CHANGES TO PAVEMENT
 STRUCTURE PER CHANGE ORDER #5

PROJECT NAME:	RANDOLPH	
PROJECT NUMBER:	STP 2932(I)	
FILE NAME:	z10c270.dgn	PLOT DATE: 6/5/2014
PROJECT LEADER:	C. LATHROP	DRAWN BY: J. GOODALL
DESIGNED BY:	B. BRESLEND	CHECKED BY: C. LATHROP
PROJECT TYPICAL SHEET 1		SHEET 8 OF 276

RECLAIMED STABILIZED BASE TYPICAL SECTION

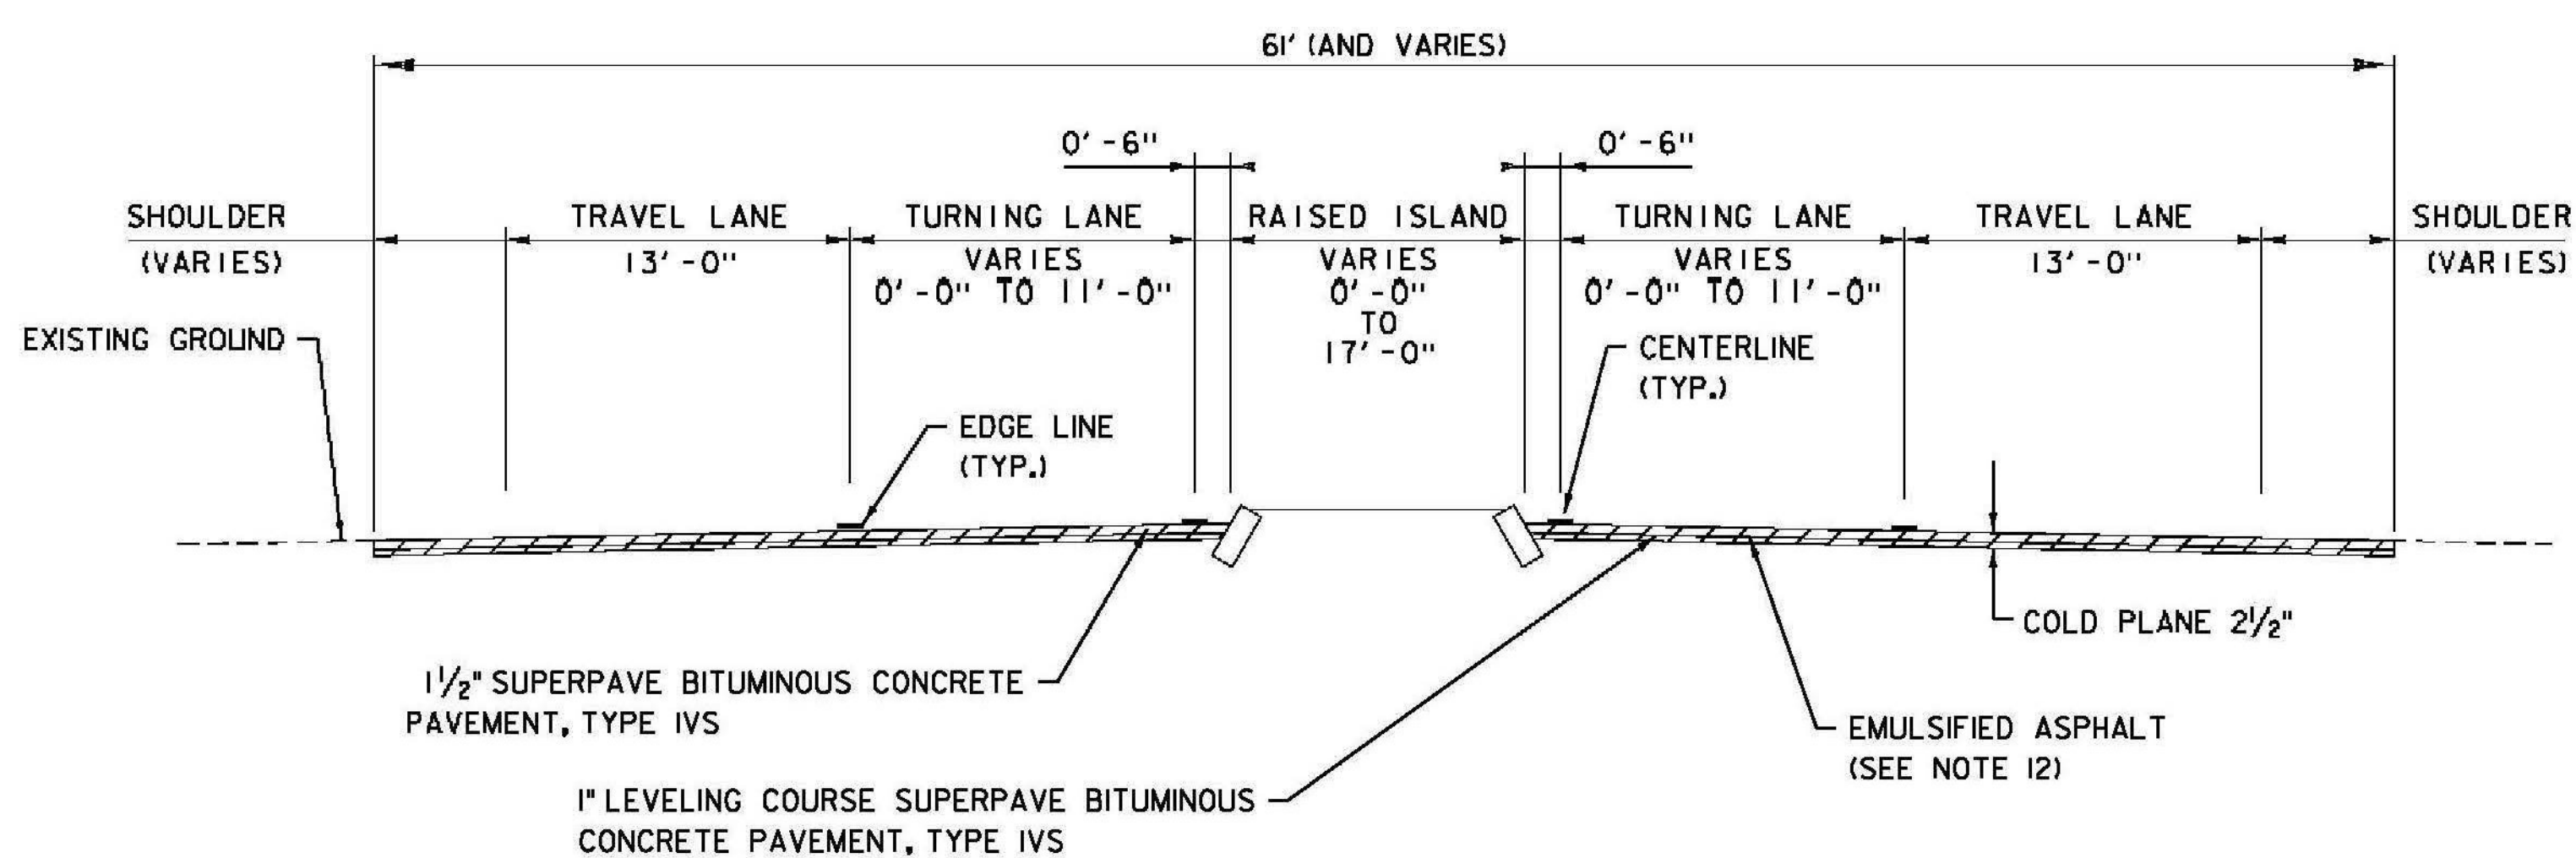
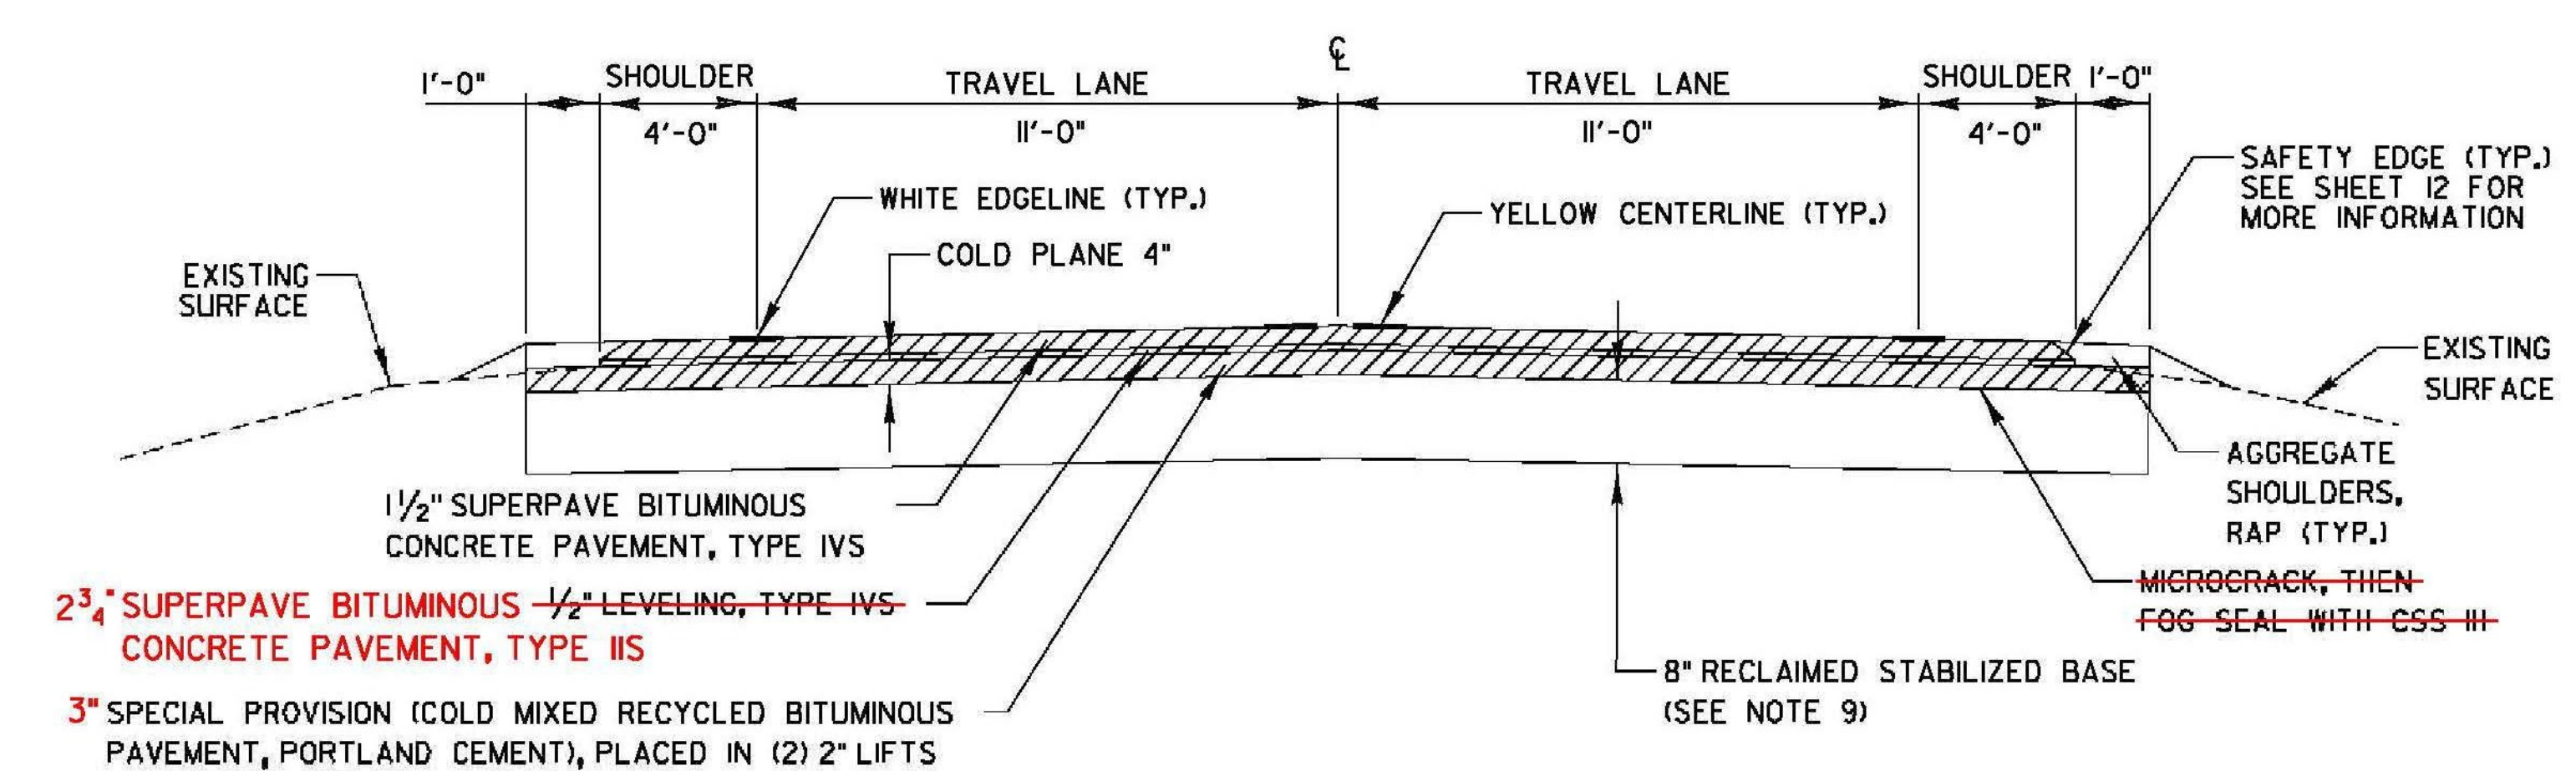
- ~~ITEM 900.683 "SPECIAL PROVISION (FOG SEAL SURFACE TREATMENT)" SHALL BE APPLIED ON THE SURFACE OF THE RECLAIMED STABILIZED BASE, PORTLAND CEMENT AT THE RATE OF 0.15 GAL/SY OR AS DIRECTED BY THE ENGINEER.~~ **FOR SEAL NOT USED (REDESIGN) C.O. #5**
